Item No.: 20B-RW-01

## NCUTCD Proposal for Changes to the Manual on Uniform Traffic Control Devices

**TECHNICAL COMMITTEE:** Regulatory and Warning Signs Technical Committee  
**ITEM NUMBER:** 20B-RW-01  
**TOPIC:** Vertical Clearance of Large Signs  
**ORIGIN OF REQUEST:** Tom Heydel, WisDOT  
Task Force: Robert Weber (Task Force Chair), Marc Lipschultz, Scott Kuznicki, Mike Kimlinger, James Sullivan  
**AFFECTED SECTIONS OF MUTCD:** Section 2A.18, 19

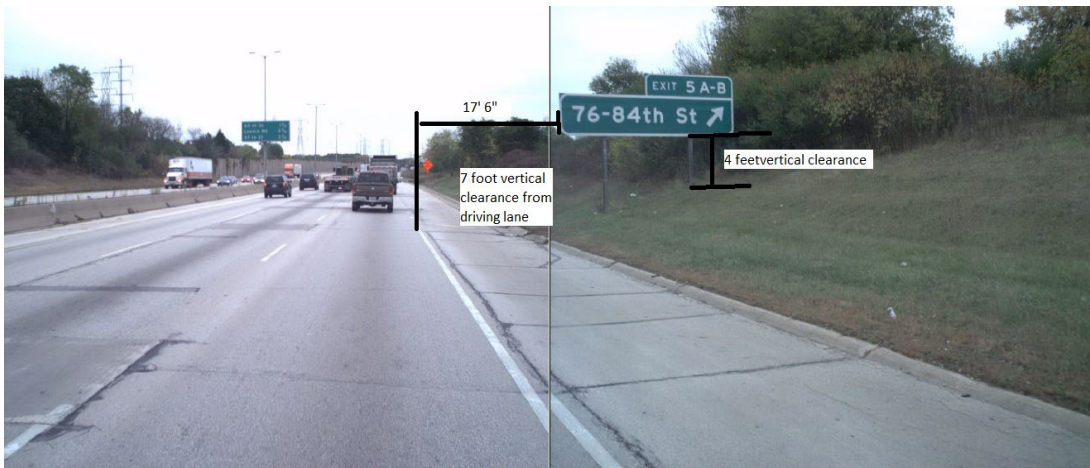
33  
34 Per paragraph 11 of Section 2A.18, for a large sign (defined as exceeding 50 square feet)  
35 mounted on multiple posts, it is required that the clearance from the ground to the bottom of the  
36 sign be 7-feet, which would include both the left and right corners of the sign. This language is  
37 similar to the 2011 AASHTO Roadside Design Guide Section 4.3.2, which states that for “large  
38 roadside sign supports” that “*The hinge should be at least 2.1 m [7 ft] above the ground so that*  
39 *no portion of the sign or upper section of the support is likely to penetrate the windshield of an*  
40 *impacting vehicle.*”

41  
42 However, there are situations in areas of deep cut (generally urban or mountainous terrain) where  
43 the lateral offset may be less than 30 feet due to right of way constraints. This then creates a  
44 dilemma in that if the sign were to be placed at 7 foot vertical clearance measured from the  
45 bottom of the far right corner (for a typical placement on the right side of the road), the resulting  
46 mounting height above road could be 11 feet or more. This would require very long posts, in  
47 turn requiring larger foundations to withstand design wind speed. An additional concern is that in  
48 certain situations this could lead to the sign being mounted much higher than 7 feet above the  
49 road, violating driver expectancy and reducing the reflected headlight retroreflectivity for  
50 modern full-cutoff headlights.

129 11 Where large signs having an area exceeding 50 square feet are installed on multiple  
130 breakaway posts, the clearance from the ground to the bottom of the sign shall be at least 7  
131 feet **for the portion of the sign within the clear zone.**

133 11a A large sign having an area exceeding 50 square feet installed on multiple breakaway posts  
134 should be mounted at least 3 feet above the ground for the portion of the sign outside of the clear  
135 zone. Where the sign has the potential to be obscured by vegetation, engineering judgment  
136 should be used to determine if a higher mounting height is needed based on local conditions.

138 11b In a steep cut section, maintaining a 7-foot mounting height above the ground at the far side  
139 of the sign could result in an excessive mounting height above the pavement (very tall posts and  
140 reduced headlight illumination).
